ENGINEERING BULLETIN

Ref Document No.	EB15006	Issue No.	1
Subject	Additional Start Valve		
Release Date	14 th May 2015

Figure 1: Extract of schematic

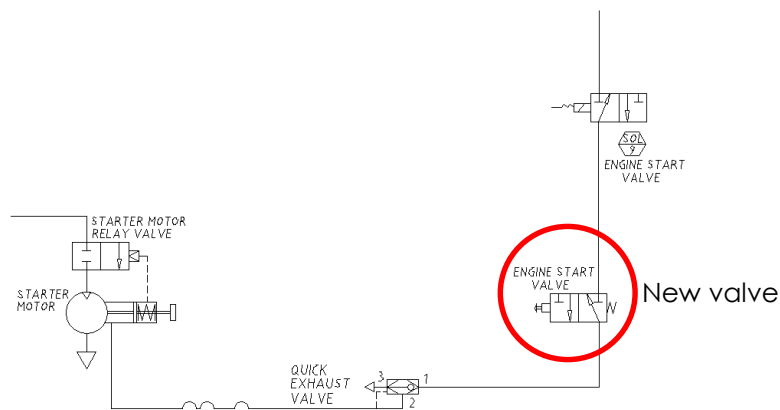
To add redundancy to the start circuit a manually piloted valve can be added inline. This valve is required to be pressed at the same time as holding the MONEx toggle switch in the start position to start the engine. The valve is independent to the MONEx system and downstream of the MONEx start switch in the pneumatic circuit. This change makes starting the COALTRAM® a two handed operation.

Adding the additional valve will not allow the starter motor circuit to energise unless the pilot valve button is depressed.
